HAWK'S LANDING SUBDIVISION

Revised for the October 5th meeting:

APPLICATION NUMBER Holdover DATE October 5, 2006

DETAIL SITE PLAN

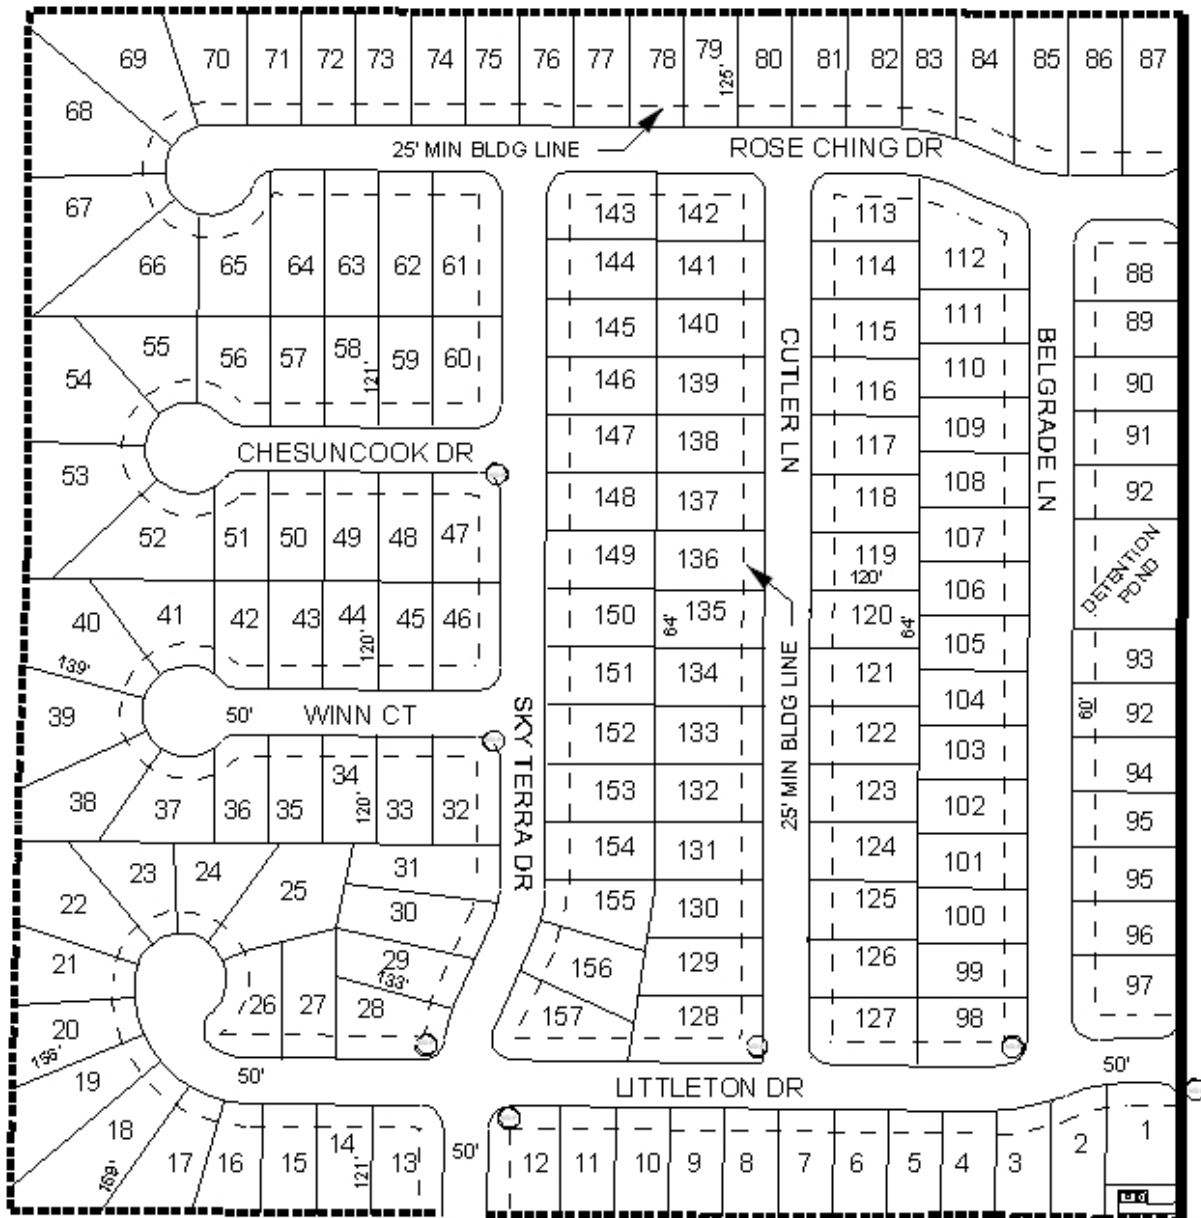
The revised site plan also appears to depict right-of-way dedication sufficient to meet the major street requirements, however, the dedication area is not labeled on the plat, although a note is provided on the plat. The plat should be revised to clearly depict and label the required dedication.

The proposed location of the sewage pump station, at the Southeast corner of the site, should be clearly labeled, and that site as well as the detention pond should be identified as common areas. A note should be placed on the plat stating that maintenance of all common areas shall be the responsibility of the home owners association.

The revised plat does not depict the 25-foot minimum building setback line for those lots which abut Ching Dairy Road. The plat should be revised to reflect the setback requirement. It should be noted that lot 87 may not be of sufficient width to accommodate the setback line from Ching Dairy Road and still provide a building site that meets market requirements.

The revised plat also depicts two lots labeled "92" and two lots labeled "95." The plat should be revised to correct the numbering.

Based on the preceding, the revised plat is recommended for Tentative Approval, subject to the following conditions: 1) placement of a label on the drawing specifically identifying the portion of the site that will be dedicated as right-of-way sufficient to provide 50 feet, as measured from the centerline of Ching Dairy Road; 2) verification that each lot will meet the 7,200 square feet minimum lot size requirement of Section V.D.2. of the Subdivision Regulations, after the Ching Dairy Road right-of-way dedication, and labeling of all lots or provision of a table indicating the size in square feet of all lots; 3) placement of a note on the plat stating that all lots are denied direct access to Ching Dairy Road; 4) correction of the lot numbering for lots 92 and 95; 5) identification of all common areas, including the detention pond and the sewage pump station, and placement of a note on the final plat stating that maintenance of detention and common areas is the responsibility of the subdivision's property owners; 6) depiction of the 25-foot minimum building setback line from all lot lines that abut public streets; 7) placement of the legal description on the final plat, as required by the Subdivision Regulations; 8) placement of a note on the final plat stating that any lots which are developed commercially and adjoin residentially developed property must provide a buffer, in compliance with Section V.A.7. of the Subdivision Regulations; and 9) provision of a certification letter from a licensed engineer to the Planning Section of Urban Development, certifying that the stormwater detention and drainage facilities comply with the City of Mobile stormwater and flood control ordinances, prior to the signing and recording of the final plat.
